Measurement Verification Page

Avalon Hingham Shipyard II

Hingham, MA

Shadow Study
March/September 21 @ 12:00PM

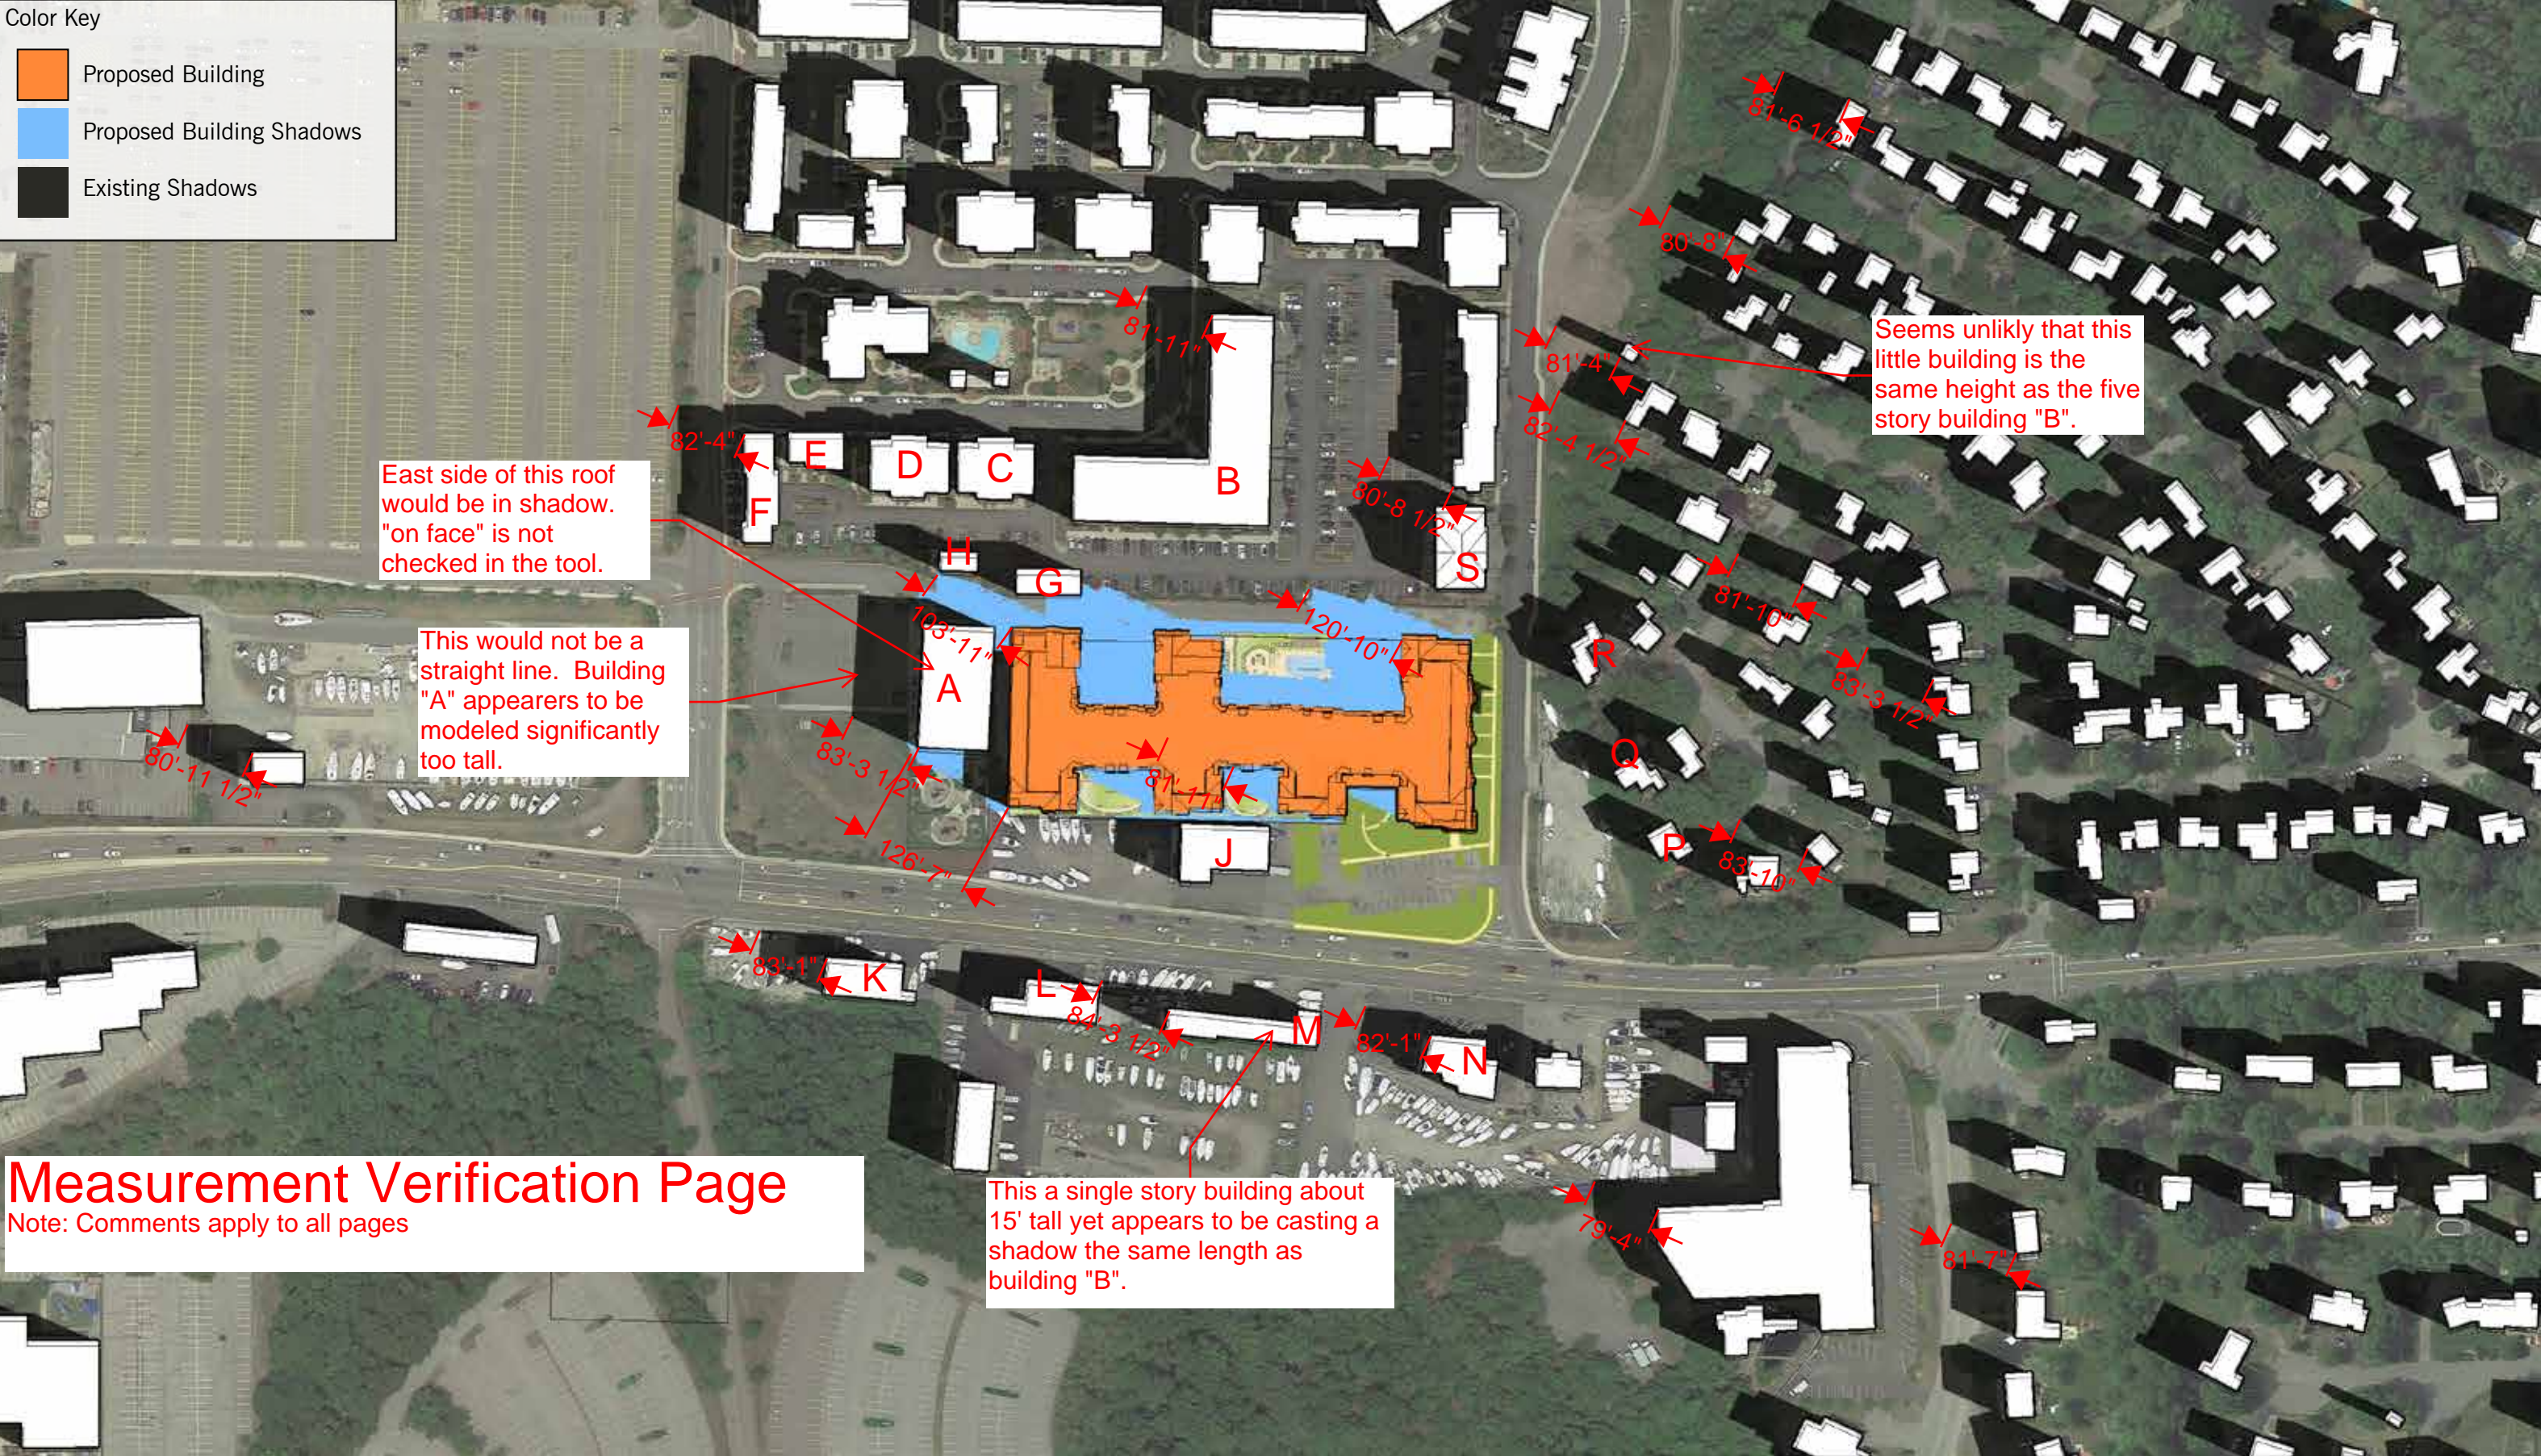
Note: Comments apply to all pages

This a single story building about 15' tall yet appears to be casting a shadow the same length as building "B".

Seems unlikely that this little building is the same height as the five story building "B".

East side of this roof would be in shadow. "on face" is not checked in the tool.

This would not be a straight line. Building "A" appears to be modeled significantly too tall.
